Illinois Department of Transportation

SUBJECT: Quad City International Airport
Moline, Illinois
Rock Island County
Illinois Project Number: MLI-4359
AIP Project Number: 3-17-0068-XX
Contract No. QU018
Item No. 4A, August 1, 2014 Letting
Addendum A

NOTICE TO PROSPECTIVE BIDDERS

Revisions based on phasing direction from the FAA. Clarification of sign removal/disposal requirements. Clarification of light adjustment due to grading.

**TYPICAL PHASING SEQUENCE
 PHASE 9 SHOWN**

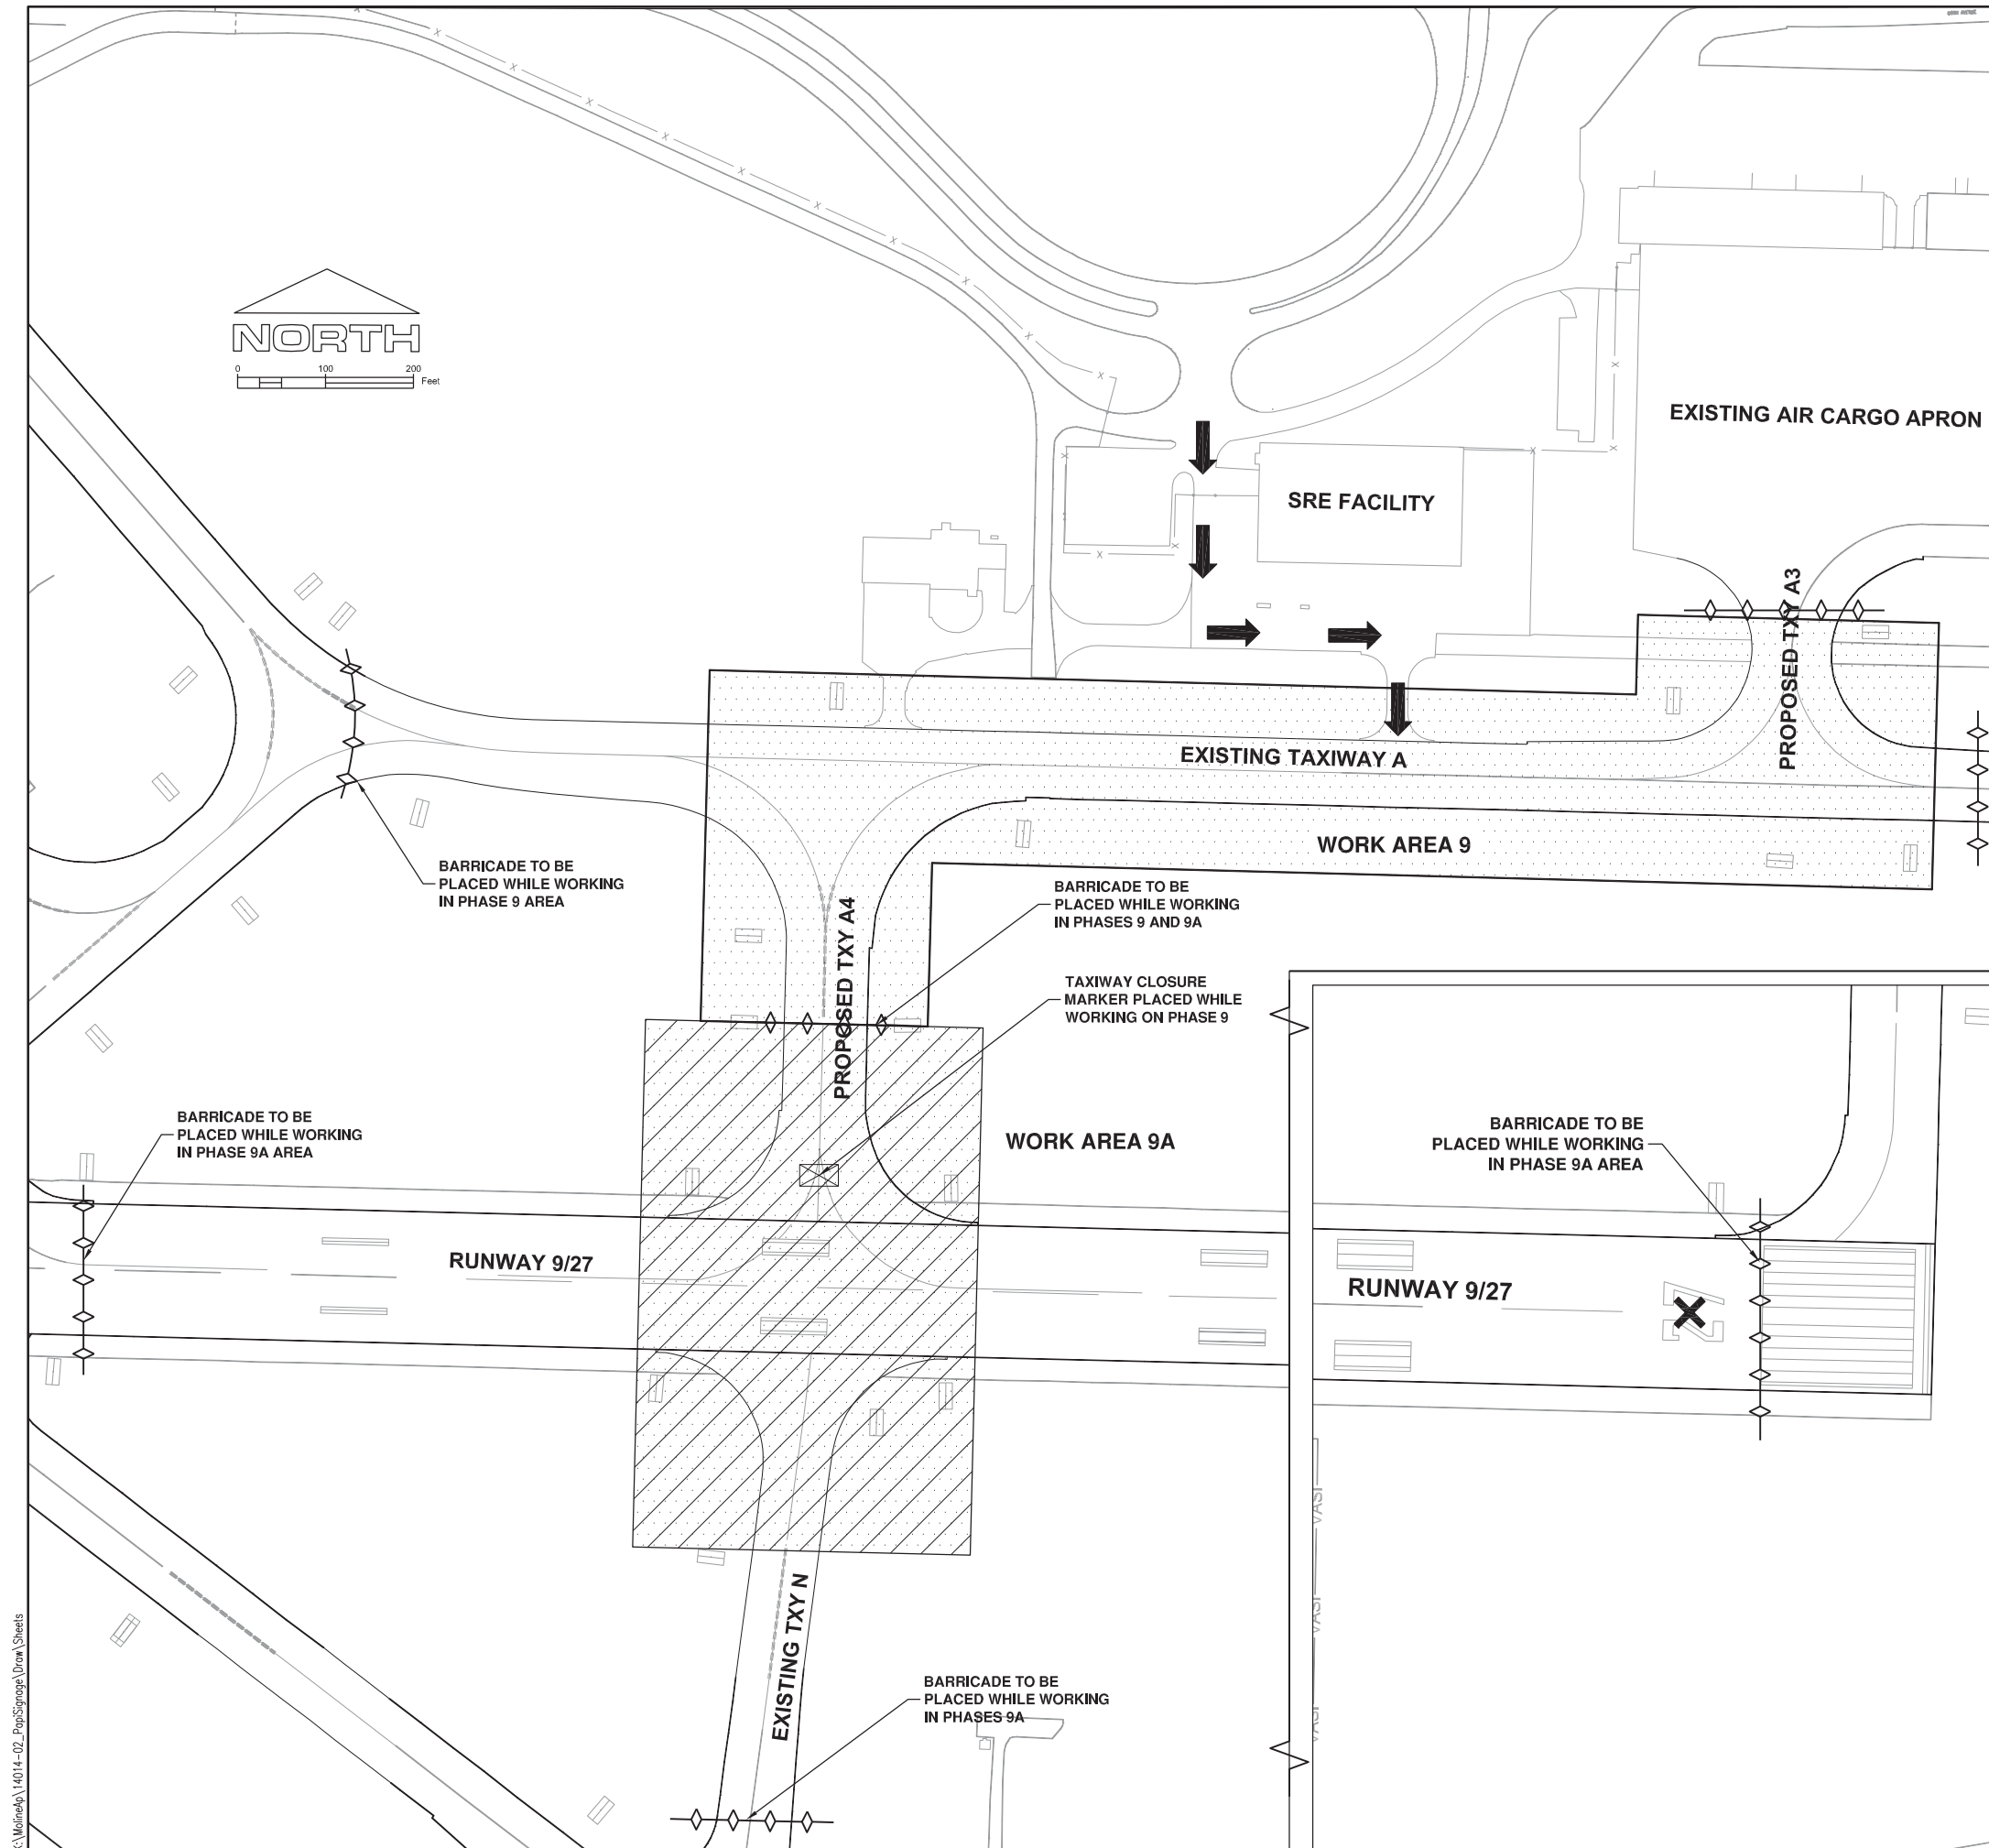
Issue Plan Sheet 3A, **Construction Activity Plan Typical Phasing**

- Detail for typical phasing barricade placement and associated notes

- COORDINATE WITH THE AIRPORT THROUGH THE RESIDENT ENGINEER 72 HOURS PRIOR TO CLOSING OR OPENING A WORK AREA.
- PRIOR TO BEGINNING WORK IN A GIVEN PHASE, THE CONTRACTOR SHALL PLACE ALL BARRICADES AT THE NEAREST ADJACENT TAXIWAY OBJECT FREE AREA (160') OR RUNWAY SAFETY AREA (300' FOR RUNWAY 9/27 OR 250' FOR RUNWAYS 5/23 AND 13/31) LIMITS SHOWN AND AS DESCRIBED IN THE CONSTRUCTION SAFETY PHASING PLAN NOTES, OR AS REQUIRED BY THE AIRPORT. BARRICADES SHALL BE PLACED AT ALL LOCATIONS REQUIRED TO PREVENT AIRCRAFT ACCESS TO PORTIONS OF RUNWAYS AND/OR TAXIWAYS WHERE WORK IS BEING PERFORMED.

- TAXIWAY CLOSURE X'S SHALL BE PLACED AT ALL CLOSED TAXIWAYS EXITING ACTIVE RUNWAYS WHEN THE TAXIWAY CLOSURE IS TO EXCEED 72 HOURS.
- LOCATE UTILITIES WITHIN THE PHASE INCLUDING BUT NOT LIMITED TO THE FAA CABLES, AIRPORT HOMERUNS AND EXISTING UNDERGROUND DRAINAGE.

- VERIFY THAT THE TAXIWAY LIGHTING CIRCUITS ON EITHER SIDE OF THE CURRENT PHASE ARE POWERED.
- LAYOUT NEW TAXIWAY GUIDANCE SIGNS, CABLE RUNS/TRENCHING AND DIRECTIONAL BORE LOCATIONS.

- INSTALL CABLE RUNS, DIRECTIONAL BORES AND TAXIWAY GUIDANCE SIGNS.
- COORDINATE WITH THE AIRPORT THROUGH THE RESIDENT ENGINEER A MINIMUM 72 HOURS PRIOR TO BEGINNING WORK WITHIN THE RUNWAY SAFETY AREA.

- PLACE RUNWAY CLOSURE MARKERS (PROVIDED BY THE AIRPORT) AT THE BEGINNING OF THE RUNWAY WORK AREA PHASE. BEGIN WORKING WITHIN THE RUNWAY SAFETY AREA. SEE CONSTRUCTION ACTIVITY PLAN NOTES & DETAILS FOR CLOSURE MARKER DETAIL.

- WORK AREAS WITHIN THE RUNWAY SAFETY AREA OF RUNWAY 9/27 SHALL BE COMPLETED UNDER A TWO (2) CONSECUTIVE CALENDAR DAY CLOSURE FOR THAT PARTICULAR WORK AREA WITH THE EXCEPTION OF PHASE 7A AND PHASE 3. PHASE 7A SHALL BE COMPLETED UNDER TWO (2) NON-CONSECUTIVE TWO (2) CALENDAR DAY CLOSURES. THE TWO DAY PERIODS WILL BE SELECTED BY THE METROPOLITAN AIRPORT AUTHORITY BASED ON WEATHER AND AIR TRAFFIC CONDITIONS. PHASE 3 SHALL BE ACCOMPLISHED THROUGH MULTIPLE NIGHTLY CLOSURES IN WHICH THE AIRPORT WILL BE HANDED OVER TO THE CONTRACTOR AT 11 PM. THE CONTRACTOR WILL HAVE UNTIL 5 AM TO COMPLETE AS MUCH WORK AS POSSIBLE AND SHALL TURN OVER THE AIRFIELD BACK OVER TO THE AIRPORT NO LATER THAN 6 AM.

- WORK AREAS WITHIN THE RUNWAY SAFETY AREA OF RUNWAY 5/23 OR RUNWAY 13/31 (PHASES 1, 2, 4 & 5) REQUIRE RUNWAY CLOSURES FOR THE DURATION OF THE WORK BEING COMPLETED WITH THAT PHASE.

- WORK AREAS WITHIN THE RUNWAY SAFETY AREA SHALL HAVE NO OPEN TRENCHES, NO EQUIPMENT, NO MATERIALS AND MEET THE APPROVAL OF THE AIRPORT PRIOR TO REOPENING THE RUNWAY.

- COMPLETE ALL WORK WITHIN THE PHASE LIMITS AND TEST ALL INSTALLED EQUIPMENT TO ENSURE THAT SIGNS AND ALL OTHER ELECTRICAL EQUIPMENT ON THE CIRCUITS ARE WORKING PROPERLY.

- COORDINATE COMPLETION OF THE CURRENT PHASE AND INTENTIONS TO BEGIN THE NEXT PHASE AND REPEAT THE PROCESS.

**INSTALL RWY 9 PAPI & AIRFIELD SIGNAGE UPGRADES
 PROPOSED MIDFIELD GRADING PLAN**

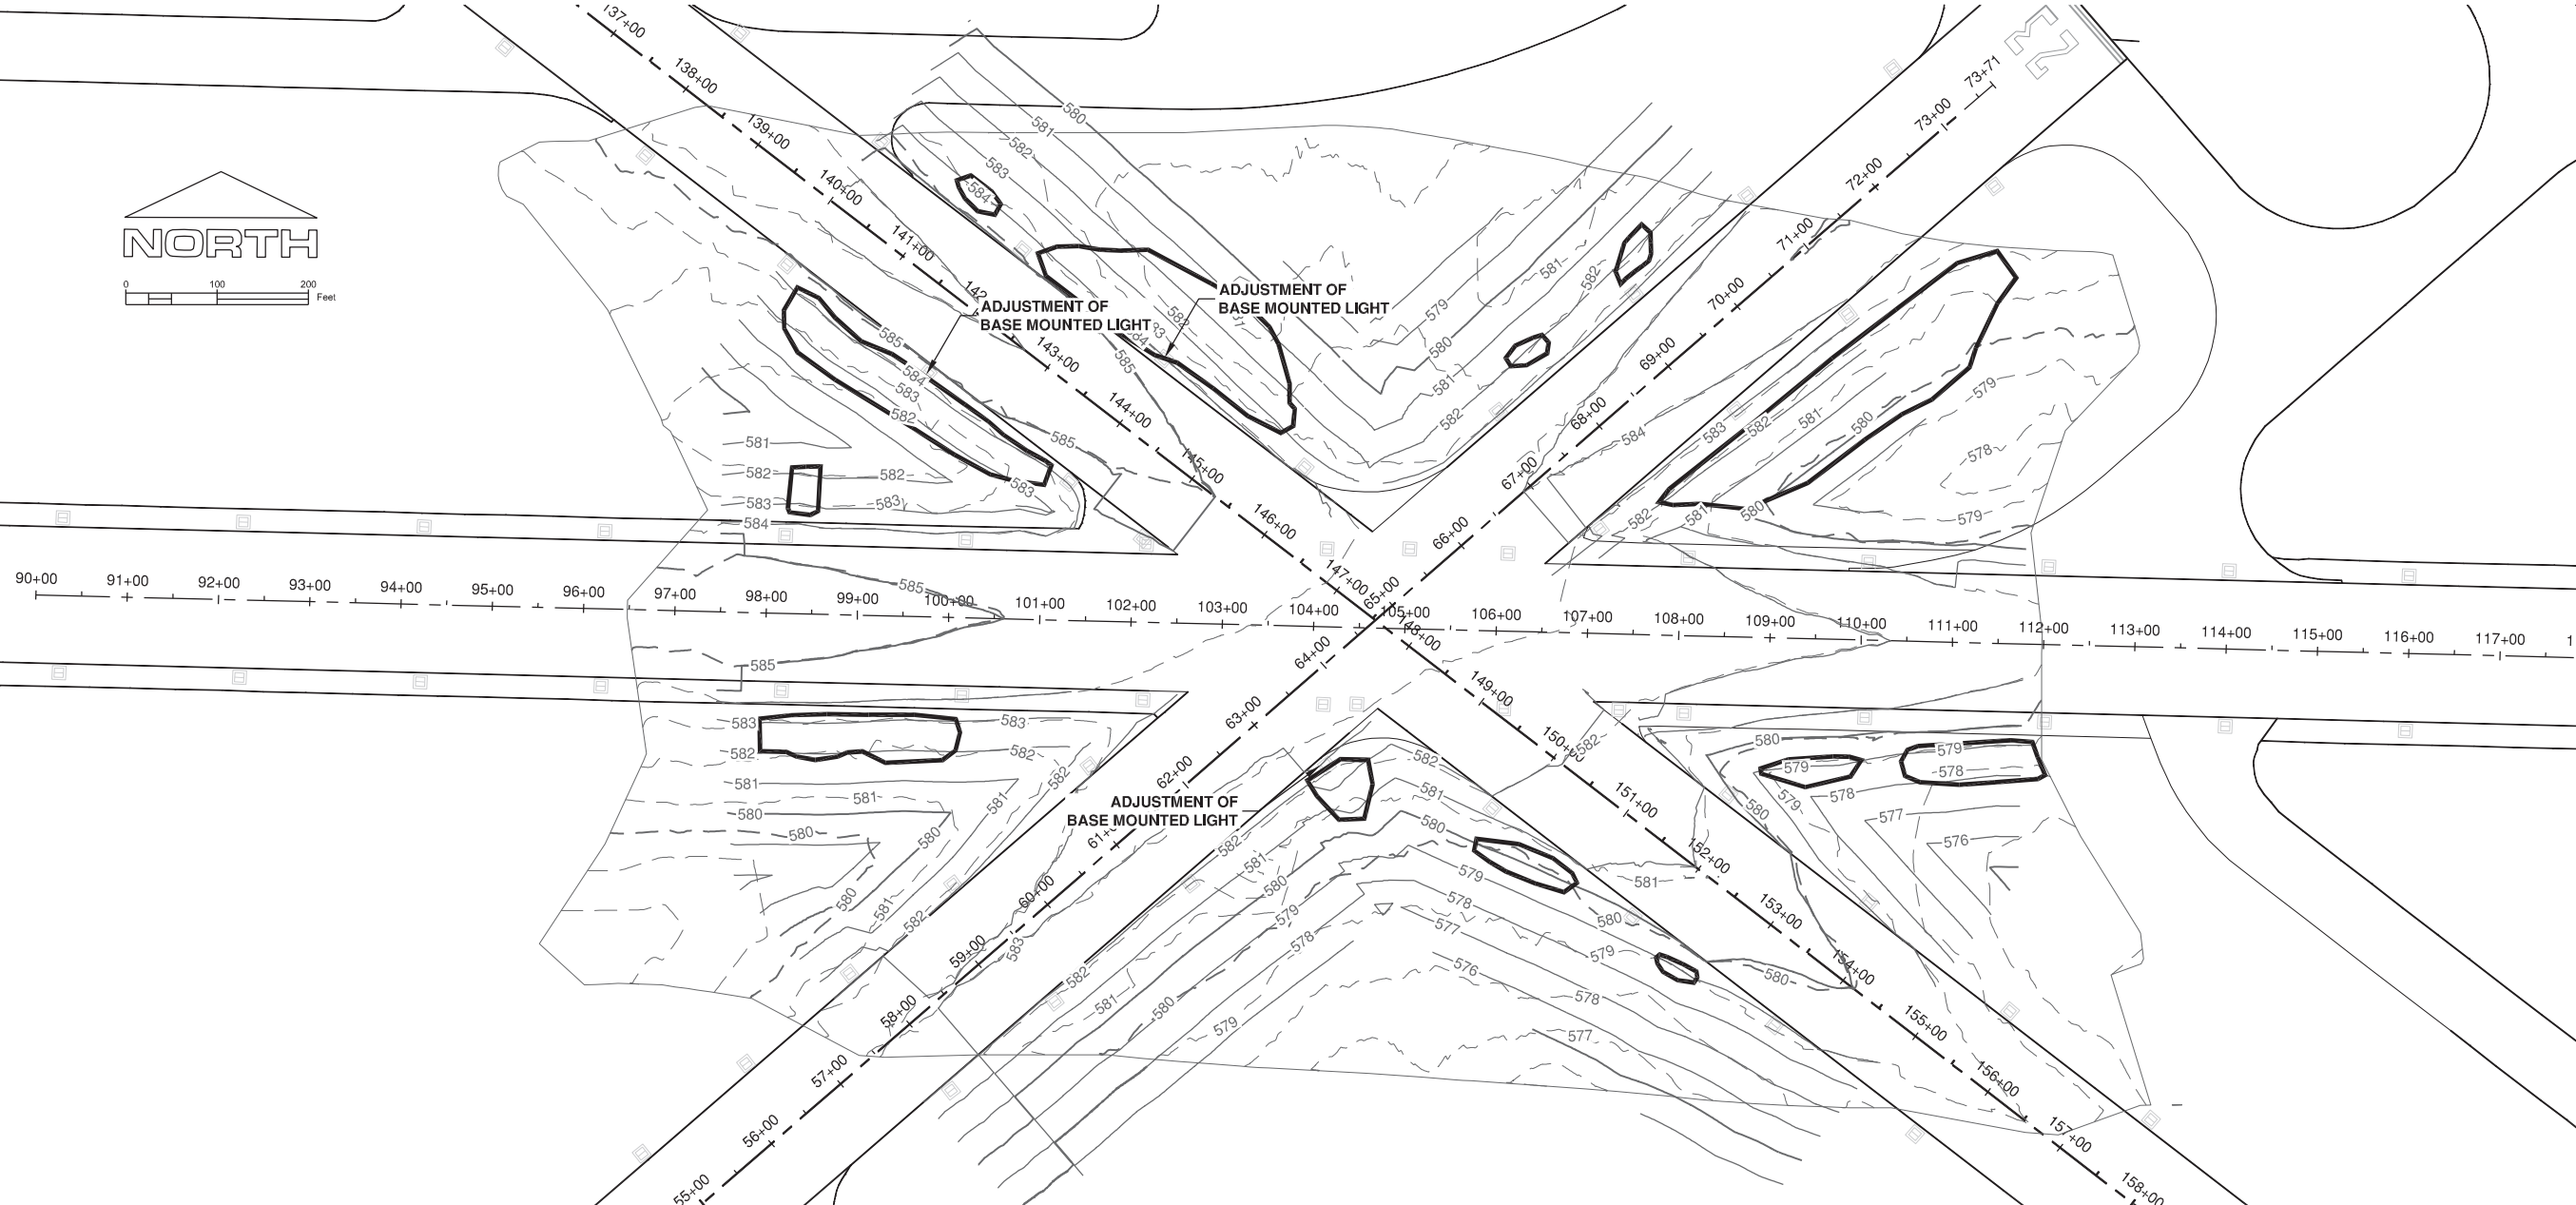
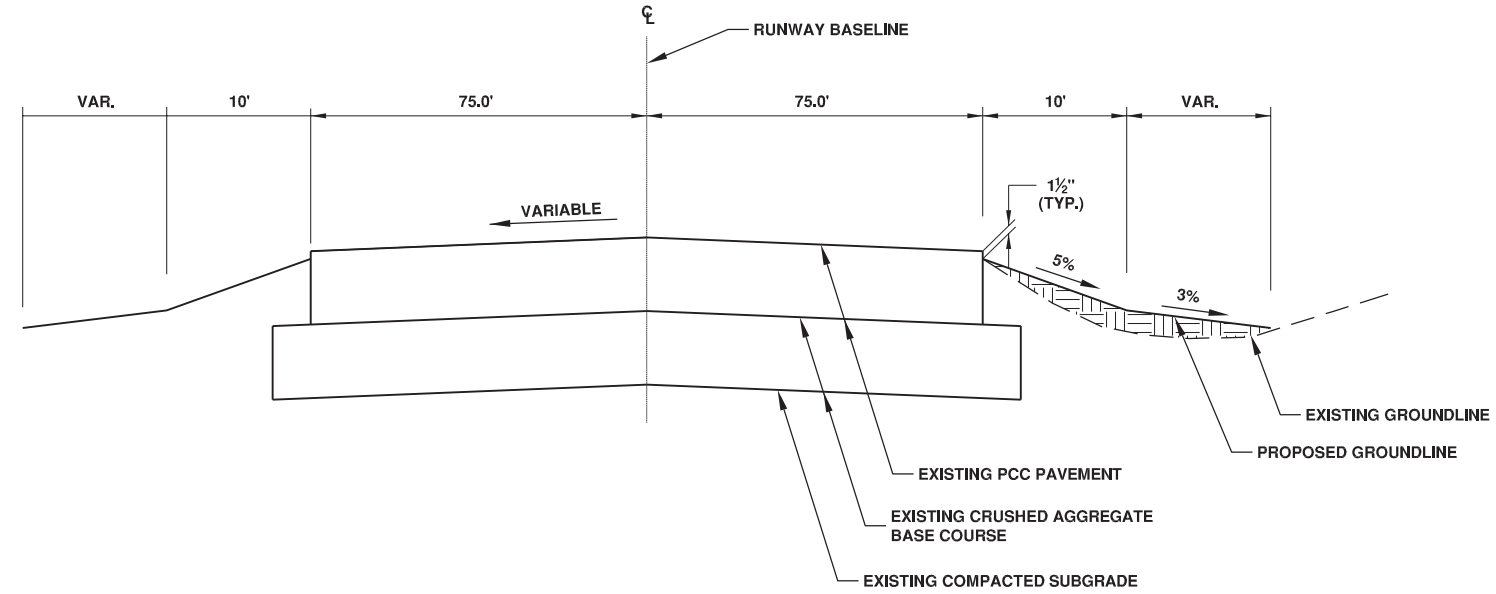
Reissue Plan Sheet 28, **Proposed Midfield Grading Plan**

- Existing Lights layer shown for clarity regarding lights to be adjusted incidental to shoulder adjustment.

- ANY BASE MOUNTED LIGHT ELEVATION ADJUSTMENT REQUIRED BY THE MIDFIELD GRADING SHALL BE CONSIDERED INCIDENTAL TO THE SHOULDER ADJUSTMENT PAY ITEM.
- MIDFIELD GRADING SHALL BE SEQUENCED CONCURRENTLY WITH THE REPLACEMENT OF THE MIDFIELD HOLD LINE SIGNS. WORK IN THIS AREA SHALL BE ACCOMPLISHED THROUGH NIGHT TIME CLOSURES AS NOTED IN THE CONSTRUCTION ACTIVITY PLAN.
- ONLY THE AREAS DELINEATED AS AREAS REQUIRING FILL SHALL BE GRADED.
- SEEDING SHALL BE INCIDENTAL TO THE SHOULDER ADJUSTMENT PAY ITEM.
